RECREATIONAL VEHICLE SERVICE CAMPAIGN

SERVICE ADVISORY 23-446

Service Advisory: 23-446

Correct Label

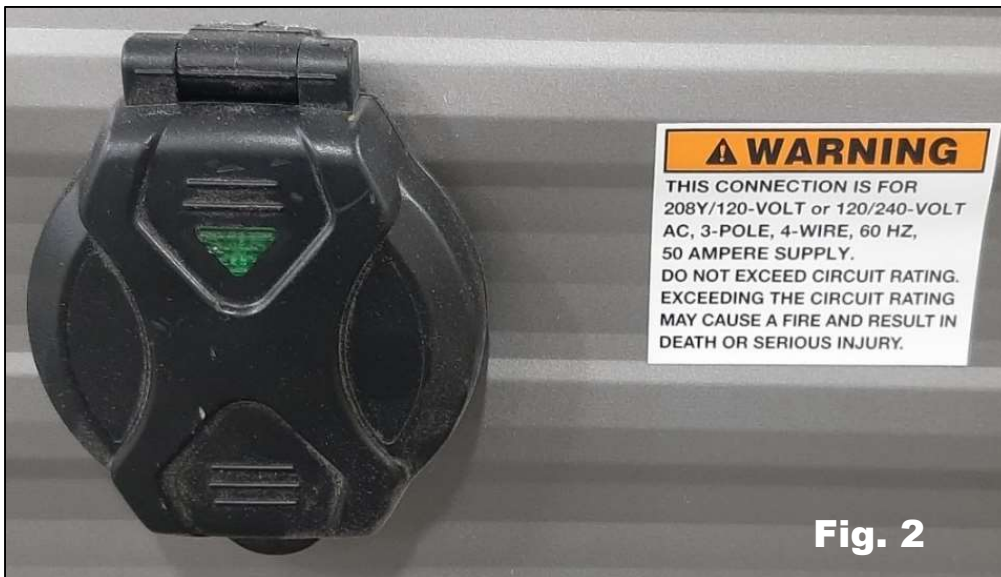
It has been determined that the shore cord receptacle label could be incorrect on some units. The remedy is to verify the current label is correct by referencing Figures 1 and 2. If incorrect stating 50 AMPERE, simply install the correct label stating 30 AMPERE on top of the incorrect label. Or, remove the incorrect label and apply the correct label. If the label is correct, no further action is required. A correct label is enclosed.
